Addendum to Drainage Technical Note v1.3

Project	Knowle Hill, Allbrook Way, Eastleigh
Project Number	23823

Date 09 October 2025

- 1.1 This Addendum to the Drainage Technical Note has been undertaken on behalf of Bargate Homes to discharge Condition 12 of Reserved Matters Application No. RM/24/98388 issued on 13 February 2025.

CLIENT	Bargate Homes				
PROJECT	Knowle Hill Allbrook Eastleigh				
TITLE	Proposed Drainage Layout Plan Whole Site				
DRAWN	M Pacifico	DATE	Oct 2024	PROJECT NO.	23823
ENGINEER	S Magowan	CHECKED		DWG. No.	REV.
SCALE	1:500 @ A1			200	P

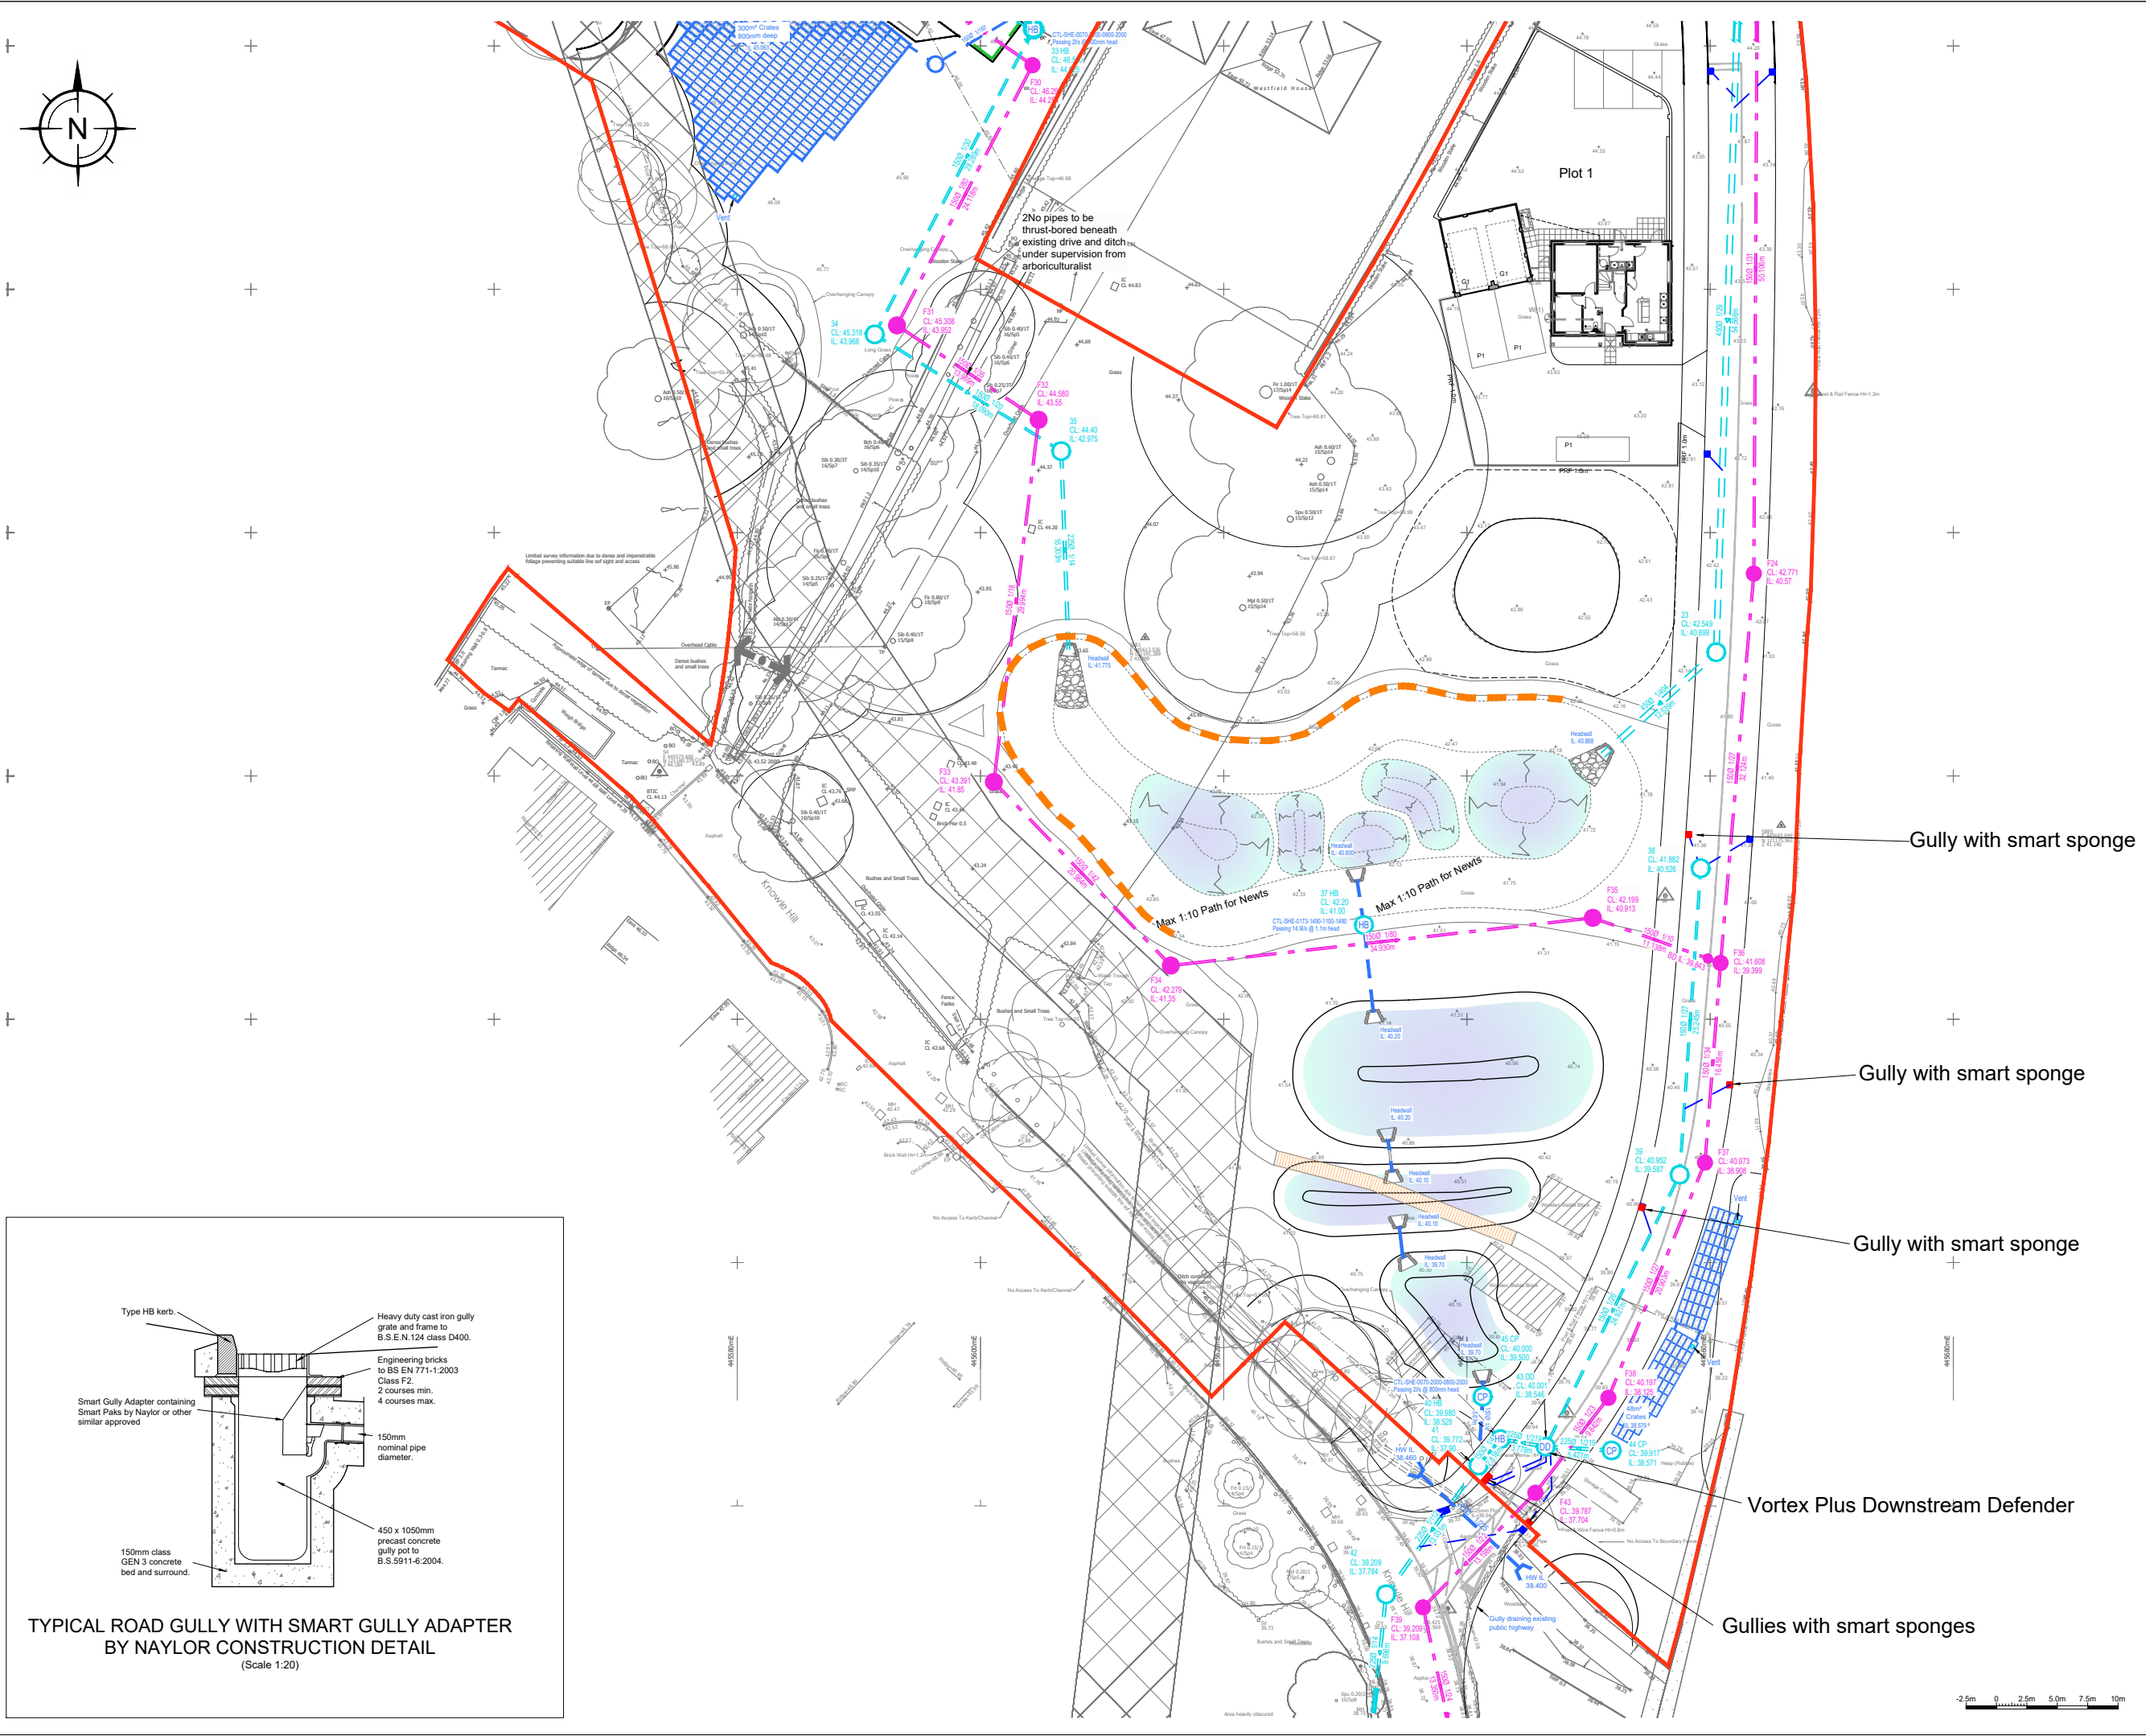
- 2.2 For the section of carriageway to the east of the pond system two forms of filtration will be provided by Smart Sponges (Smart Gully / Smart Paks by Naylor or other similar approved) within the road gullies and a Vortex Plus Downstream Defender prior to the surface water discharging to the public surface water sewer beneath Knowle Hill.

- 2.4 Drawings 23823_200_P and 23823_203_N have been updated to indicate which gullies shall contain the proposed smart sponges. Drawing 23823_203_N also indicates the Smart Gully Adapter construction detail. These drawings can be found at the rear of this Addendum.
